**City of Bellevue
Development Services Department
Land Use Staff Report**

Proposal Name: Shelter Short Plat

File Number: 20-110570-LN

Decisions Included: Preliminary Short Plat (Process II)

Figure 1 – Preliminary Short Plat Proposal

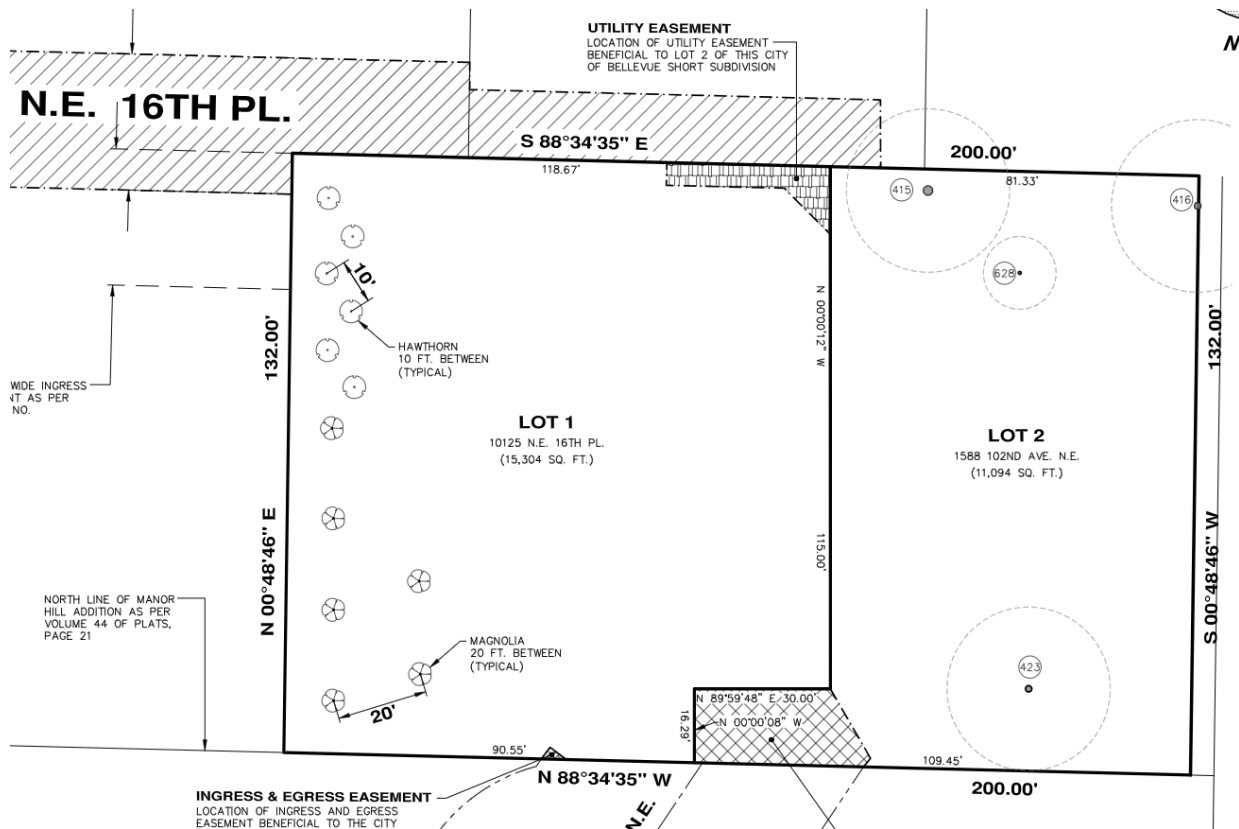
The site triggers minimum requirements #1-9. Lot 1 will utilize bio-retention for a portion of the roof runoff for stormwater mitigation. The remaining roof area and the driveway will be routed to the private storm system and downstream to the proposed on-site culverts. The walkways will be mitigated via permeable pavements. Lot 2 will utilize a dispersion trench for a portion of the roof to mitigate stormwater runoff. The remaining roof area will be routed to a non-infiltrating bio-retention cell with overflow to the existing on-site ditch and routed to the private on-site storm system leading to the proposed on-site culvert. The driveway and walkways on lot 2 will be mitigated via permeable pavement. There is less than 5,000 square feet of proposed pollution generating hard surfaces, so MR #6 is not triggered. There is less than 10,000 square feet of effective hard surface, so MR #7 is not triggered.

There are two proposed ¾"x1" water meters in 102nd Ave NE off the existing 4" DI water main. If there are any existing services, they must be abandoned back to the water main.

Each lot is proposing to connect into the existing 8" concrete sewer main in NE 16th Pl. The connection points are on private property. Verify the existing easements extend to the property line for each lot's connection. The sewer stub for lot 2 appears to pass under two rockeries. It may be beneficial for the stub on lot 2 to extend directly north to avoid passing under the rockeries as well as the need for an easement over lot 1. Any existing unused connections must be abandoned back to the sewer main.

The original design included an access easement through the southeast corner of Lot 1 for access to Lot 2. It also included the retention of two significant invasive Laurel trees. The proposal was modified to remove the access easement by changing the proposed lot line locations. The tree retention was modified to include replanting in lieu of retention as to remove the invasive species and replace them with native and non-invasive species that better fit the character of the residential neighborhood.

TREE PRESERVATION PLAN

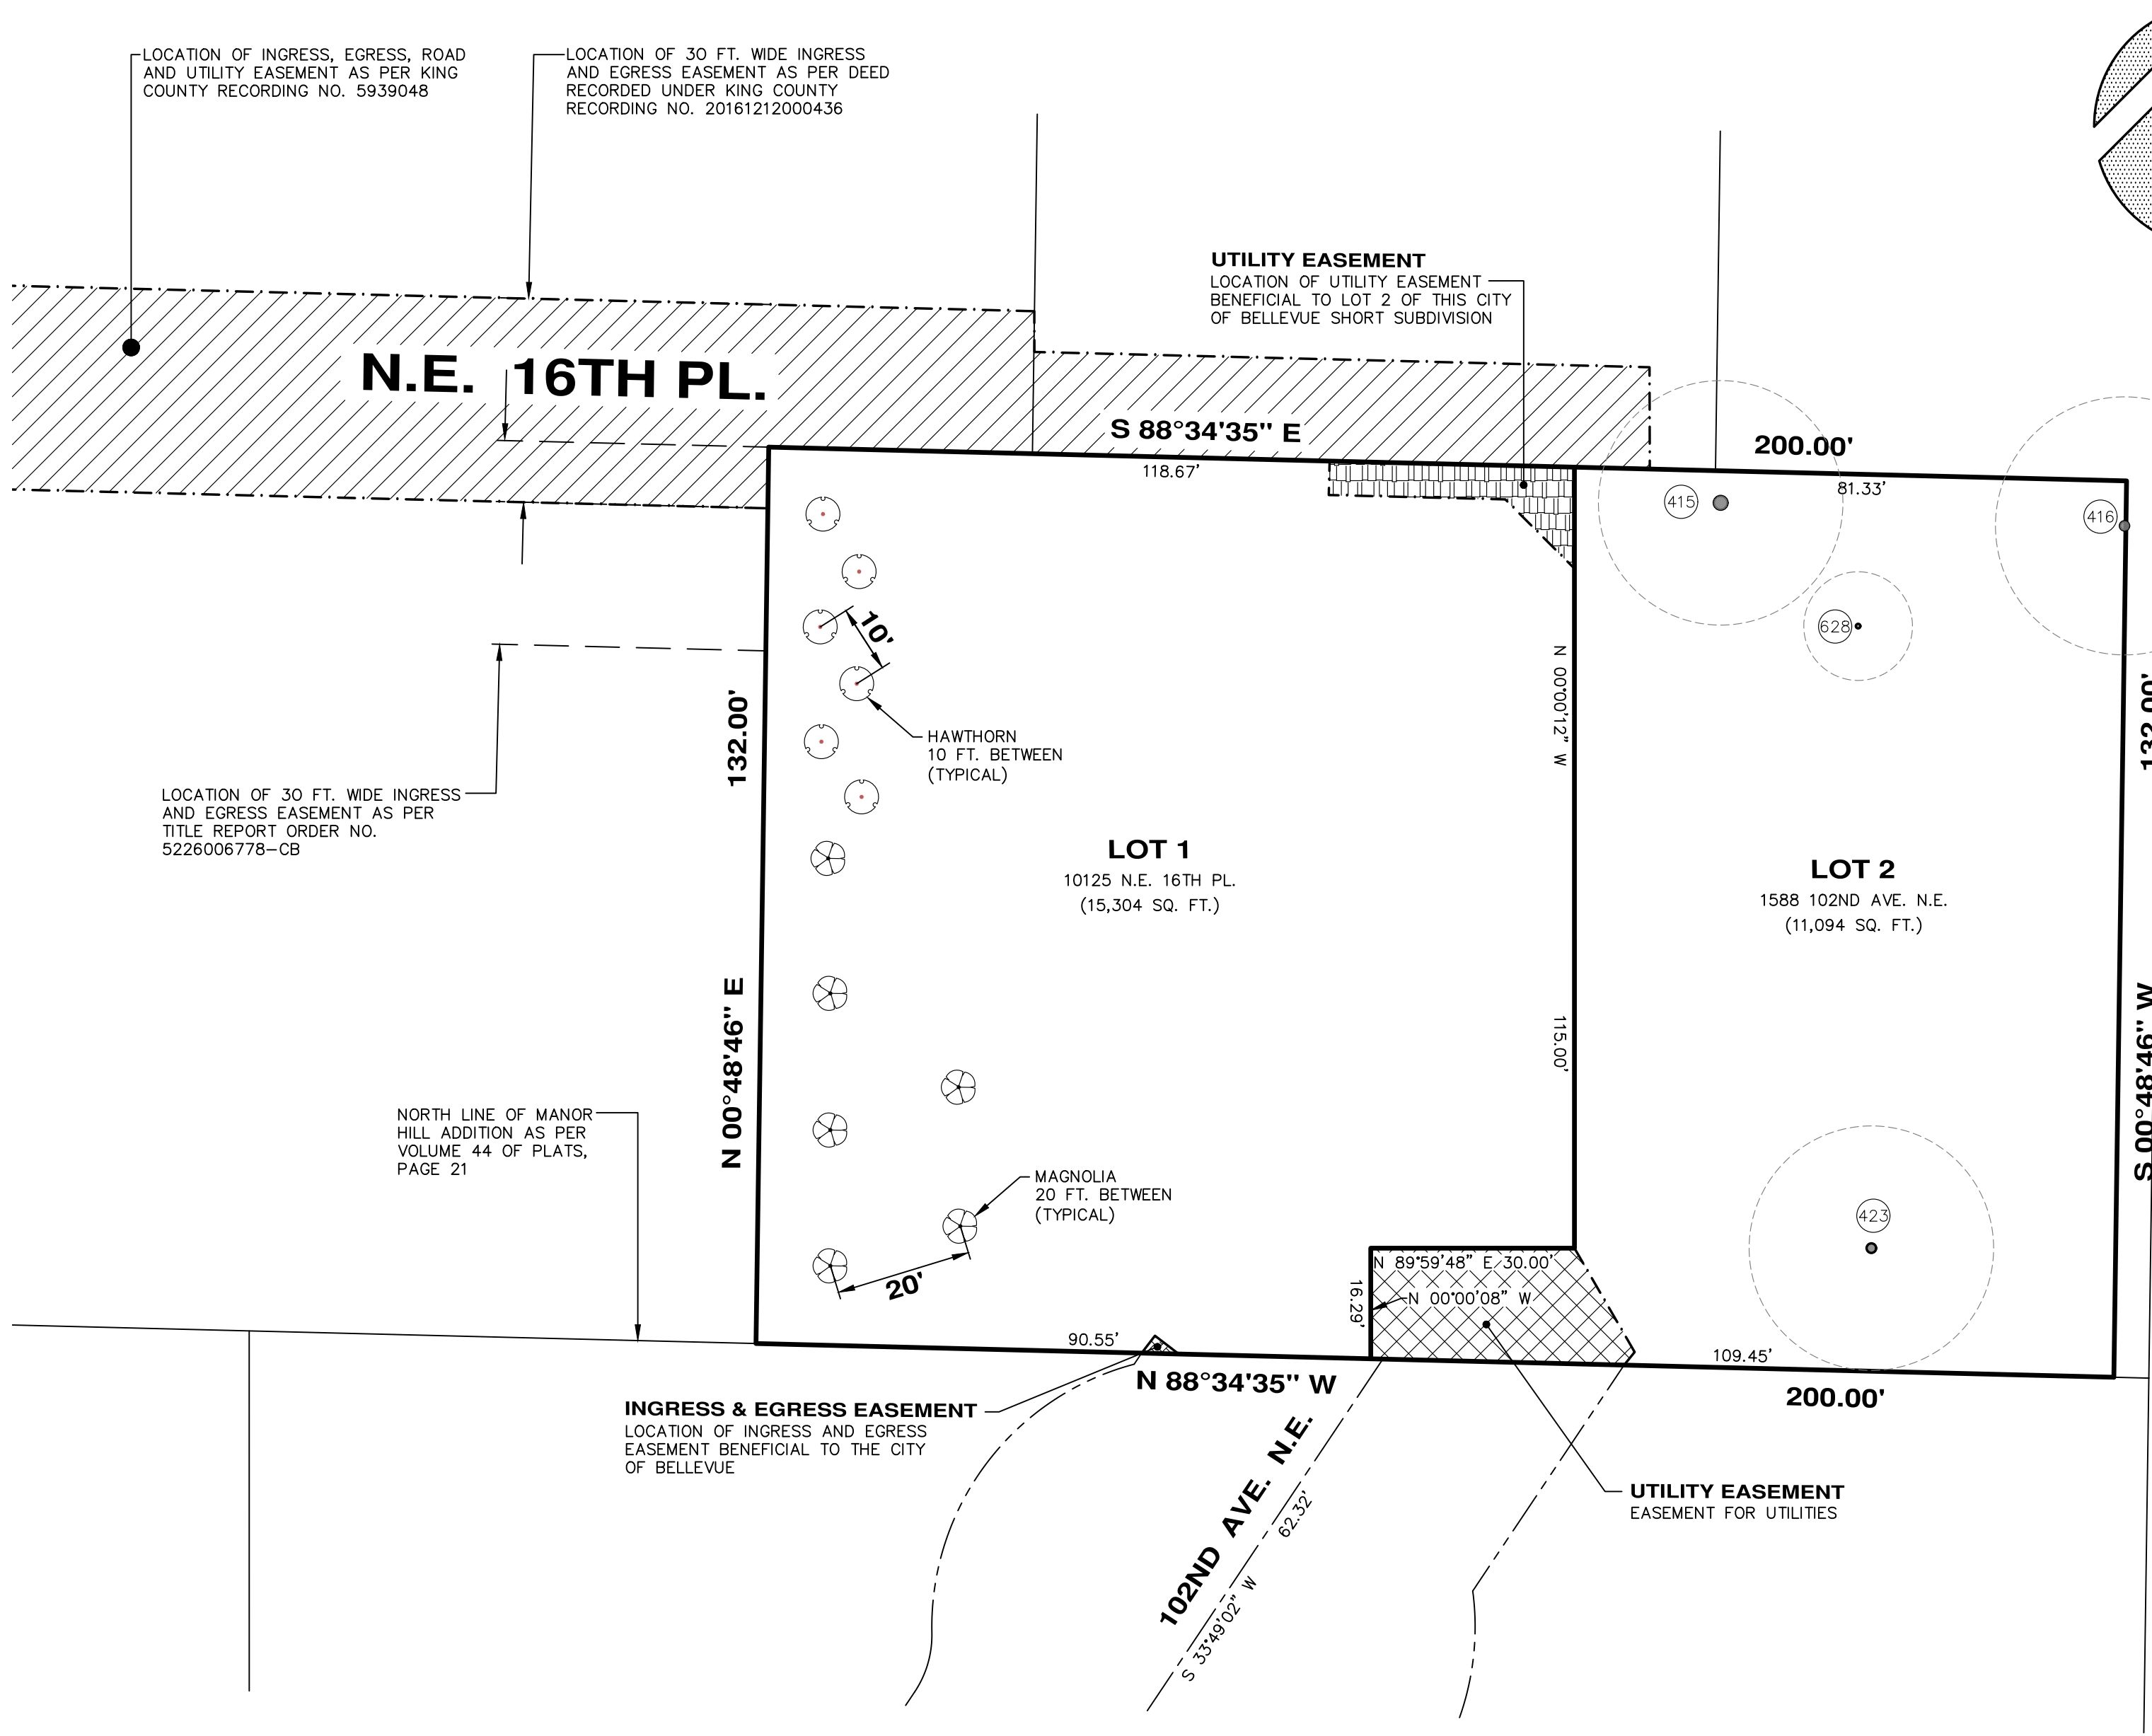
A Tree Preservation Plan that portrays the drip-line, the diameter size, and common name of each significant tree to be retained must be recorded with the final short plat mylar. The Tree Preservation Plan must contain the following note:

During future home construction, the dripline of the trees to be saved shall be fenced to prevent clearing & grading activities within the dripline area.
